# CHRISTOPHER P. STATILE, P.A.

Regarding: **Block 2201, Lot 12, Borough of Hillsdale**  
**5 Strawberry Hill Road: Variance Application PZ-06-24**  
**Marianne Illian, Applicant and Owner**

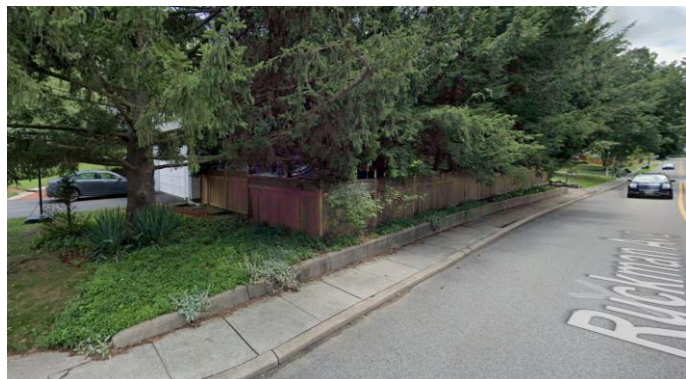
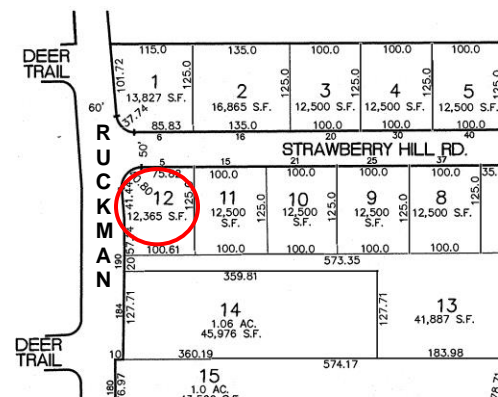
Note curb along back of sidewalk.
